## Generalized Future Land Use Map Comments Summary 6/20/18

Summary of comments discussed at 6/7 and 6/11 PC meetings. Areas for additional discussion are highlighted in **orange**. Areas where GFLU has been changed based on PC direction are highlighted in **grey**.

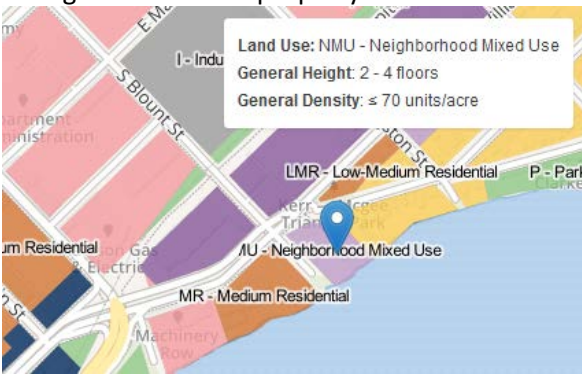
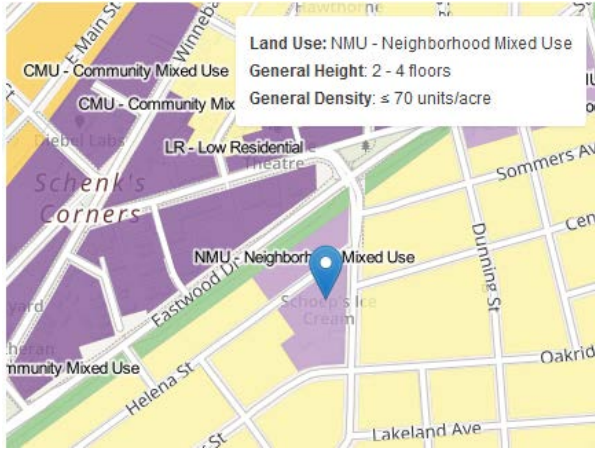
11	5/25 Dwyer & Lathrop Email	<p>Change parcels along Harvey St. between Schmidt Pl. and Hill St. from MR to LMR to better match the Hoyt Plan designation of 2-3 floors and 16-25 DU/ac.</p> 	<p>The area described at left is <b>not</b> specified for 16-25 DU/ac in the Hoyt Plan. In fact, the plan states that the area has “opportunity for higher density uses through lot assembly and redevelopment.” The area in question (area G on page 36 of the Hoyt plan) is specified to transition from taller buildings along University Avenue to a 2-3 story maximum along Harvey Street. 2-3 stories is within the MR range. The Comp Plan residential categories not only address height, but also building form. Staff feels that the building forms within the MR category are more appropriate for this area than the LMR category. The recommendations in the Neighborhood Plan as far as a 3 story height limit will remain.</p>	Maintain current MR designation.	N

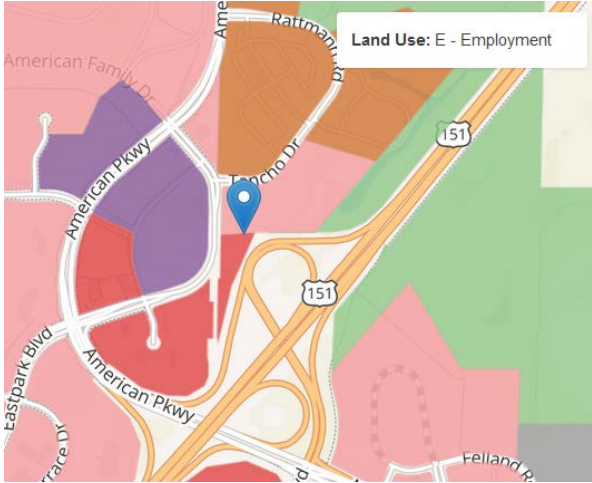
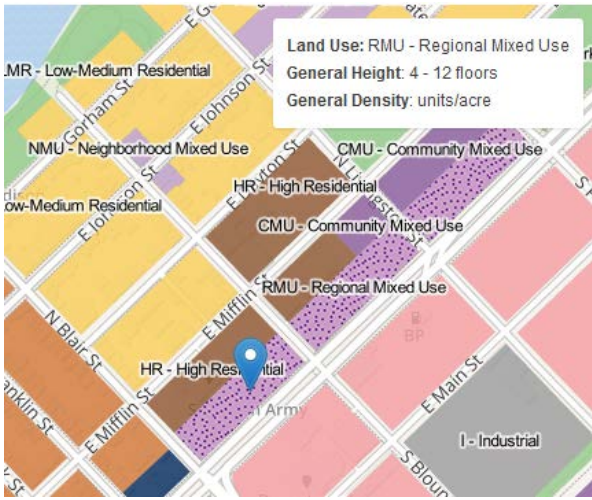
15	5/19 Leigh Email	<p>Leave the entire block from W. Main, Proudfit, W. Brittingham and S. Brittingham as LR.</p>	<p>The Commission instructed staff to change the block bounded by W. Main, Proudfit, Brittingham, and S. Brittingham to LMR at their 6/7/18 meeting.</p>	<p>Comment addressed at 6/7/18 PC meeting.</p>	<p>Y (see GFLU map)</p>
16	6/5 Pelski Email	<p>“the neighborhood and its residents, after several meetings and discussions, strongly oppose adjusting zoning/height restrictions from the 2006 plan to High Density for the Properties between West Washington, Proudfit, and West Main St; these properties are known as Parkview Apartments, Journey and the vacant property on the corner. Additionally, the Monona Bay neighborhood and its residents oppose moving from low-density for the block surrounded by West Main Street (700 block), South Brittingham, West Brittingham and Proudfit streets. Finally, the properties on the West Shore of Monona Bay will be addressed in our plan, and we ask that we maintain the 2006 plans regarding height and density.”</p>	<p>See discussion below regarding HR/MR for the Parkview Apartments. The Commission instructed staff to change the block bounded by W. Main, Proudfit, Brittingham, and S. Brittingham to LMR at their 6/7/18 meeting.</p>	<p>See #17 below.</p>	<p>Y (see GFLU map)</p>

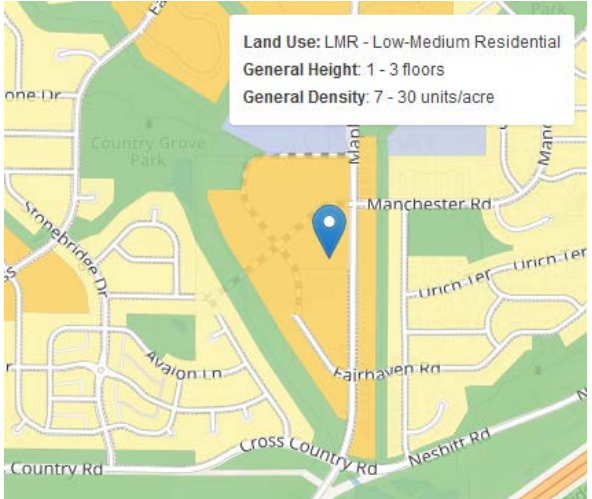
19	6/4 Klafka Email	<p>There is not enough discussion about the land consumption and impacts of the Dane County Regional Airport. More analysis of adverse impacts should be included, and there should be discussion of relocating the airport outside of the city, as has been done in Austin and Denver.</p>	<p>Continuing to manage airport impacts should be done going forward, but is not discussed in the Plan because it does not rise to the level of needing an action. Staff does not support relocation of the airport, which would likely cost billions of dollars and have few benefits.</p>	Maintain airport designation.	N

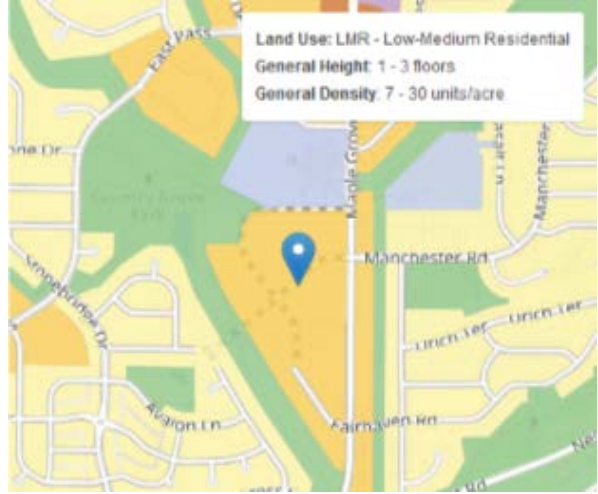
22	6/1 Keller Real Estate Letter	Change the zoning on the 400 and 500 blocks of W. Washington Ave. from MR to UMX.	Mr. Keller appears to have confused zoning with future land use mapping. The Comprehensive Plan does not change zoning on any property. MR is a future land use designation in the Comprehensive Plan, and UMX is a zoning district under city ordinances. Future land use mapping for the downtown in the Comprehensive Plan implements the land uses specified in the Downtown Plan, with the exception of a handful of changes where the recently constructed projects better fit within a Comprehensive Plan category. This approach was endorsed by the Plan Commission at a previous work session.	Maintain uses as mapped.	N

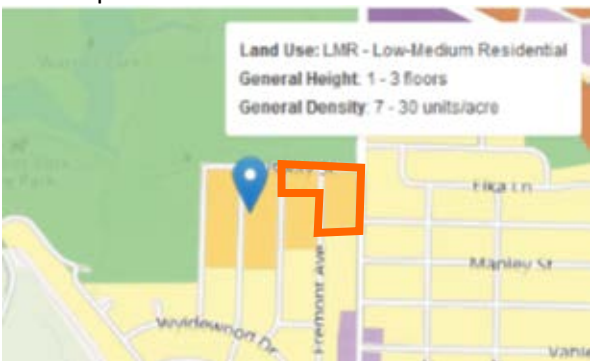
26	6/7 Lehnertz Message	<p>Reinstate 2006 Comprehensive Plan map note #1 for the Schoep's site.</p> 	<p>Map note text: <i>“This is currently the site of a long-established ice cream production facility located within a predominantly residential neighborhood. If this site is redeveloped at some future time, a mix of residential development and neighborhood-serving commercial or employment uses is recommended rather than redevelopment with a new industrial use. The existing grocery adjacent to the ice cream plant is a significant amenity to the surrounding residential area, and a neighborhood grocery should be retained as part of any future redevelopment. Buildings should be generally compatible in scale with existing residential and commercial buildings in the area.”</i></p> <p>Staff believes that the old map note is adequately covered in the plan text and on the map itself. The map note above recaps the definition of NMU (“a mix of residential development and neighborhood-serving commercial or employment uses”), states that NMU is desired over industrial (which is what the GFLU map shows already), expresses a desire to keep the existing grocery (NMU is not an indication that it should disappear), and states that buildings should be compatible in scale with their surroundings (there is already a general statement to this effect in the Plan, and emphasizing it here and not in other NMU areas that may also see redevelopment does not seem appropriate).</p>	<p>Do not add the 2006 map note back into the 2018 GFLU map.</p>	N
